[Docket No. FAA-2020-0883; Project Identifier 2019-CE-034-AD]

Airworthiness Directives; Rockwell Collins, Inc. Flight Display System Application

ACTION: Notice of proposed rulemaking (NPRM).

Figure 1 to paragraph (g)(1)(iii); placard location on bezel

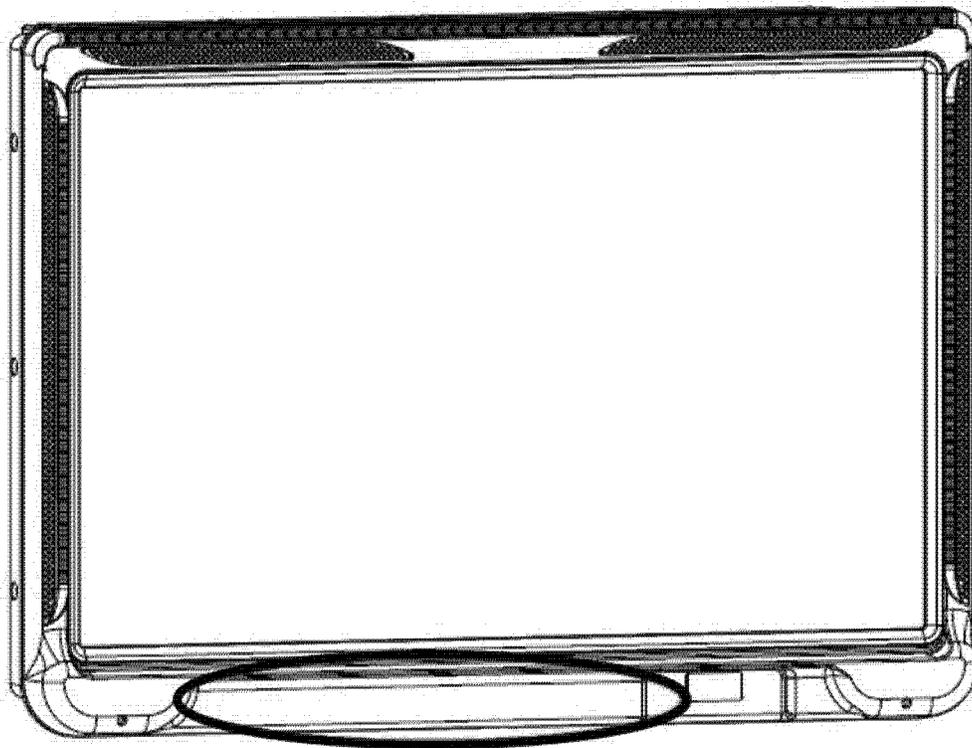
(ii) Fabricate a placard for each aircraft primary flight display, using at least 1/8 inch letters, with the following text: TCAS Flight Ops—TA Only mode (TA/RA mode prohibited).

(iii) Install the placard on the bottom of each aircraft primary flight display bezel in the area depicted in figure 1 to paragraph (g)(1)(iii) of this AD.
